PROJECT  
**SOP 3.1**

**PROPOSED DEVELOPMENT**  
SYDNEY OLYMPIC PARK  
STAGE 3 - SITE 1

DRAWING TITLE  
**GROUND FLOOR LEVEL**  
PRINT DATE  
06.09.10  
PROJECT ID  
SOP3.1  
DRAWING NO.  
DA06  
ISSUE  
7

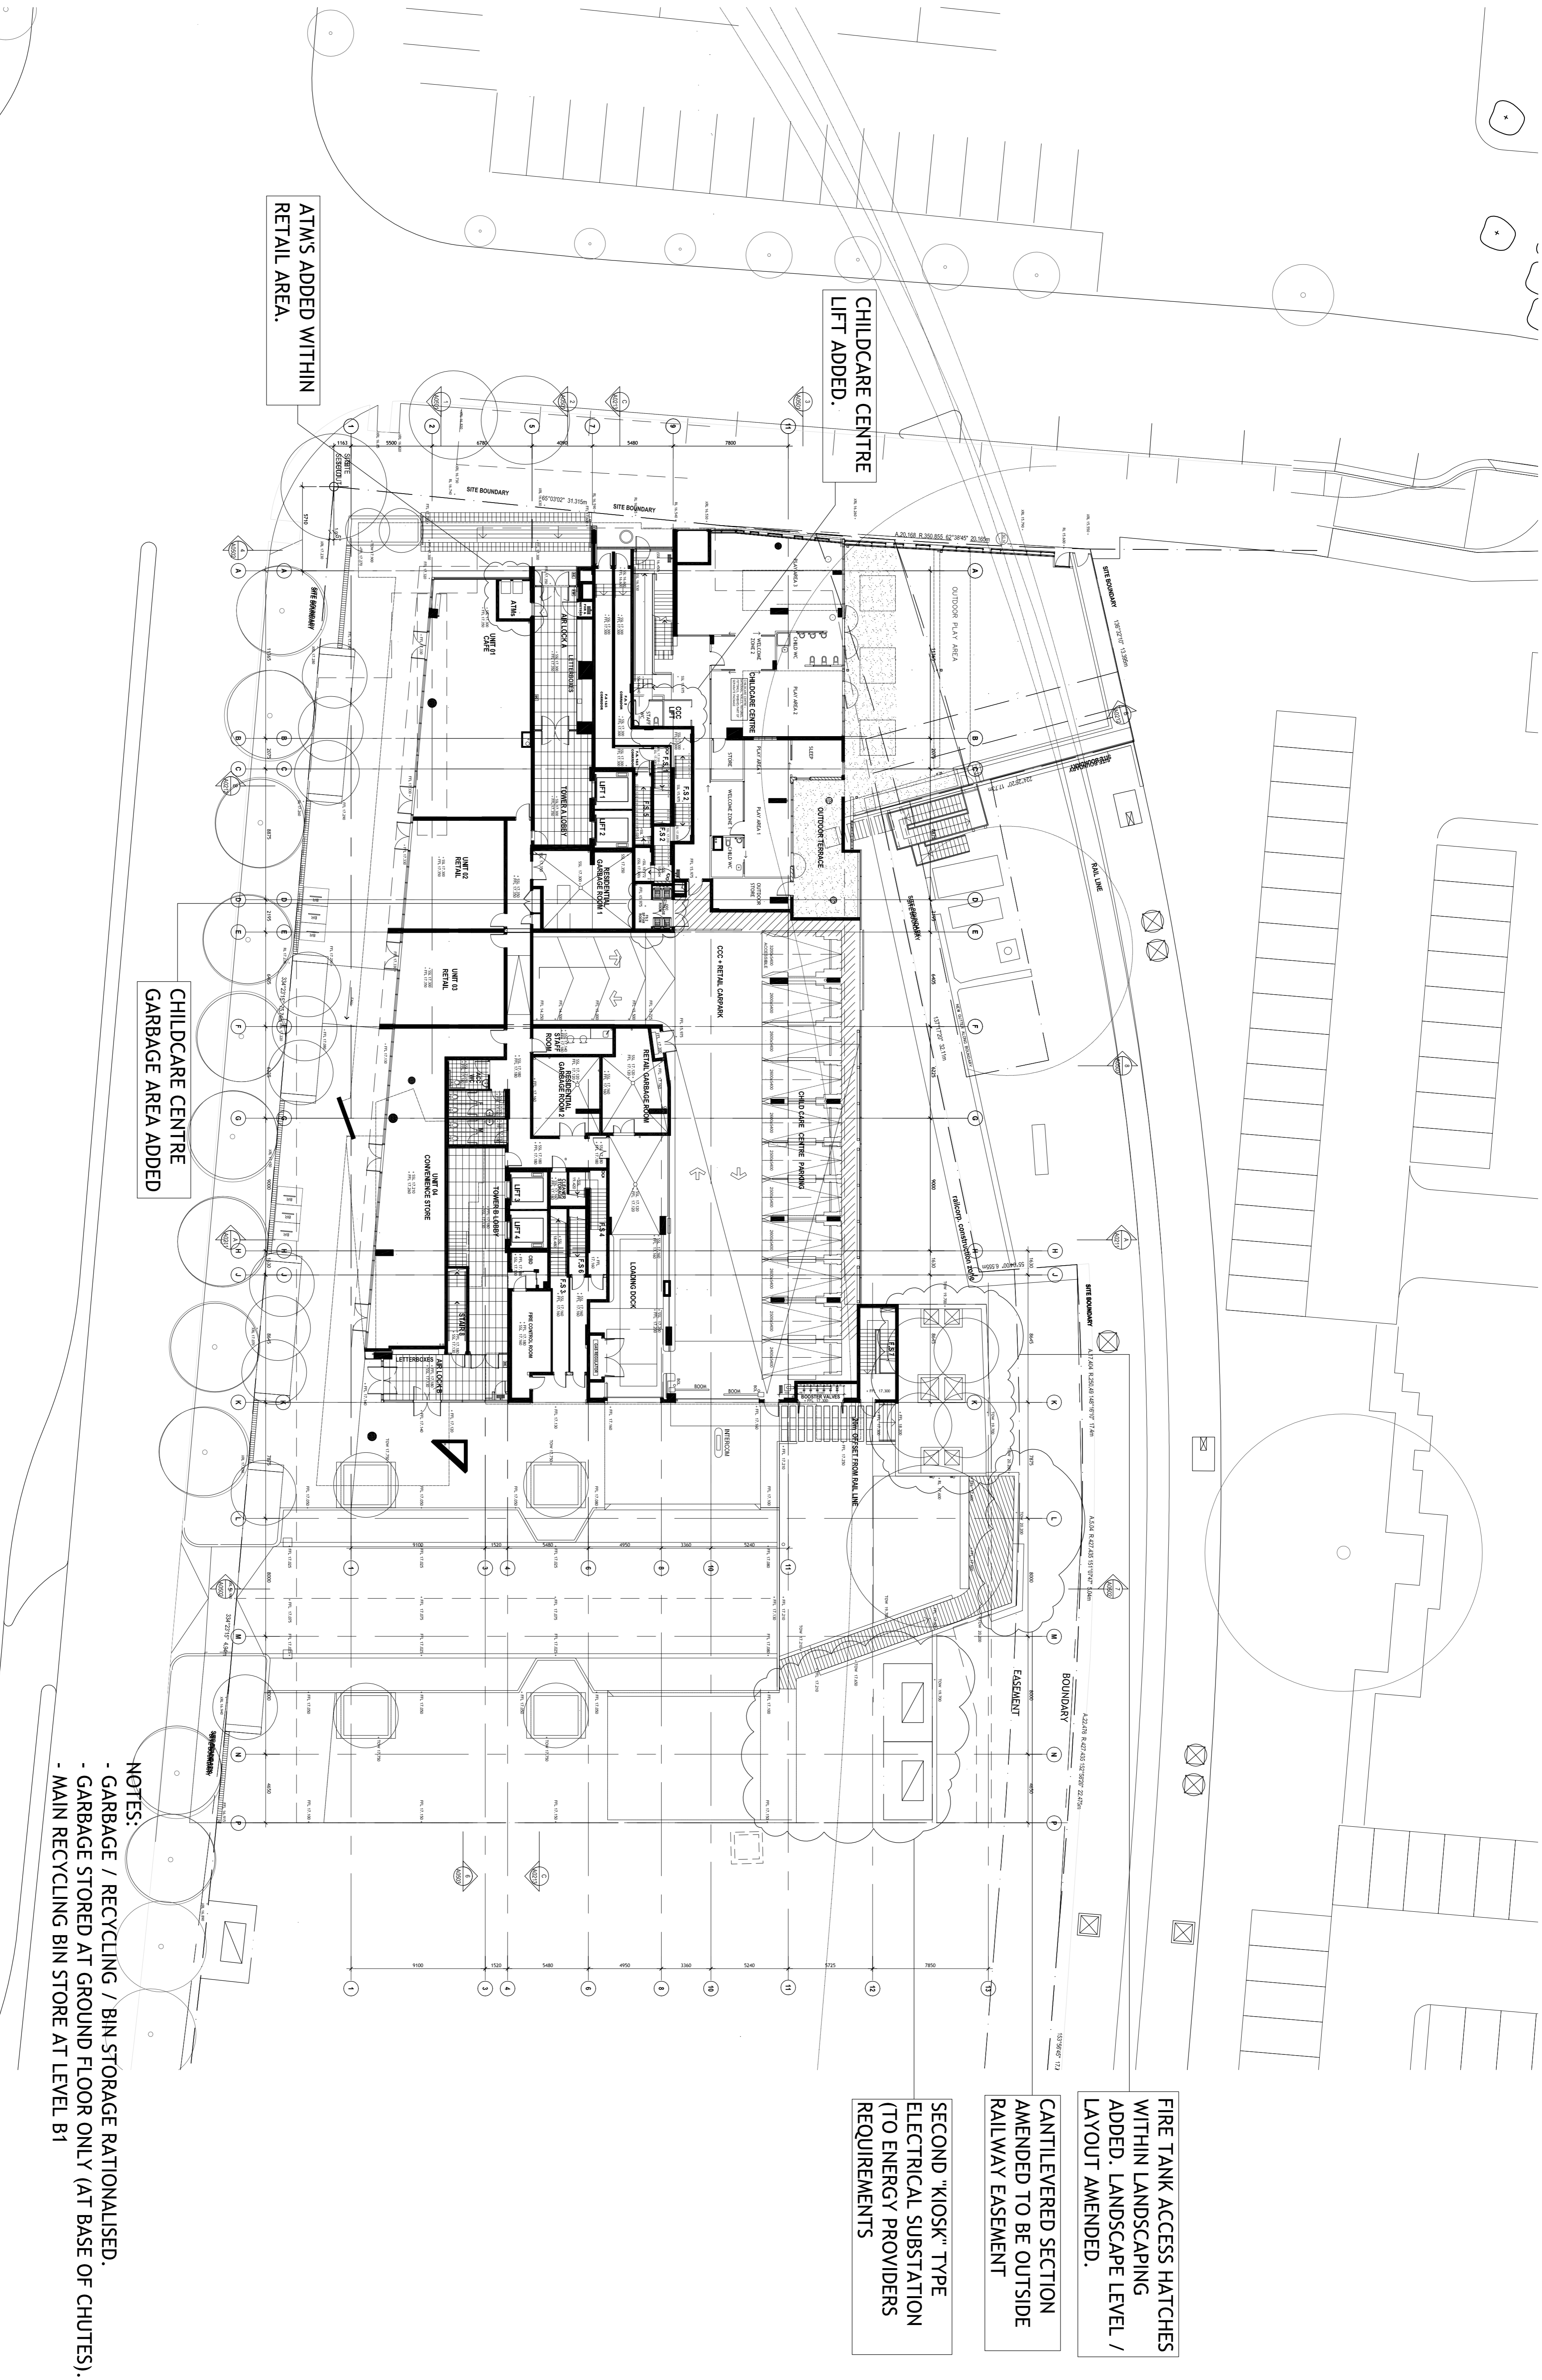
CHILD CARE CENTRE  
LIFT ADDED.

ATMS ADDED WITHIN  
RETAIL AREA.

CHILD CARE CENTRE  
GARBAGE AREA ADDED

- NOTES:
- GARBAGE / RECYCLING / BIN STORAGE RATIONALISED.
  - GARBAGE STORED AT GROUND FLOOR ONLY (AT BASE OF CHUTES).
  - MAIN RECYCLING BIN STORE AT LEVEL B1

SECOND "KIOSK" TYPE  
ELECTRICAL SUBSTATION  
(TO ENERGY PROVIDERS  
REQUIREMENTS)

CANTILEVERED SECTION  
AMENDED TO BE OUTSIDE  
RAILWAY EASEMENT

FIRE TANK ACCESS HATCHES  
WITHIN LANDSCAPING  
ADDED. LANDSCAPE LEVEL /  
LAYOUT AMENDED.
